## **Access Compliance Report Public Rights-of-Way** (Curb Ramps)

Intersection ID: 49388 Main Street: SHORTHORN\_ST **Cross Street: DAMASCUS\_ST** Location: NE **Overall Compliance: No** ADA ID: 12E03D498BBA Ramp Type: Perp Initial Pass/Fail: Fail Severity Score: 21.25

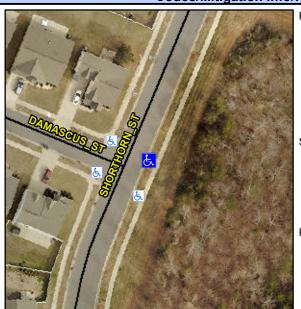
Possible Solutions:	9
Remove & Replace Entire Ramp.	N
	N
	N
	N
	N
	N
Surveyor Notes:	N
N/A	N
	1
	N
	N
PROW/ADA:	N
Not Found, R304.5.1, R304.5.3	N
	N
	N
	N

Field Measurements/Component Compliance							
Compl	liance Description	Data	Compl	iance Description	Data		
N/A	Ramp Length (in)	95.0	Yes	Ramp Slope (%)	7.4		
No	Ramp Width (in)	47.0	No	Ramp XSlope (%)	5.2		
N/A	Flare Type LT	N/A	N/A	Flare Type RT	N/A		
N/A	Flare Slope LT (%)	N/A	N/A	Flare Slope RT (%)	N/A		
N/A	Flare Traversable LT?	N/A	N/A	Flare Traversable RT?	N/A		
N/A	Landing Length (in)	N/A	N/A	DWS Provided?	N/A		
N/A	Landing Width (in)	N/A	N/A	DWS Contrast?	N/A		
N/A	Landing Slope (%)	N/A	N/A	DWS Length (in)	N/A		
N/A	Landing X Slope (%)	N/A	N/A	DWS Full Width?	N/A		
N/A	Landing Curb? (Y/N)	N/A	N/A	DWS Offset (in)	N/A		
N/A	Shared Landing?	N/A					
N/A	Gutter Ponding?	N/A	N/A	Gutter Slope (%)	N/A		
N/A	Gutter Lip Ht (in)	N/A	N/A	Gutter X Slope (%)	N/A		
N/A	Painted X Walk1?	No	N/A	Painted X Walk2?	N/A		
	X Walk 1 Direction	To NW		X Walk 2 Direction	N/A		
N/A	X Walk 1 Width (in)	N/A	N/A	X Walk 2 Width (in)	N/A
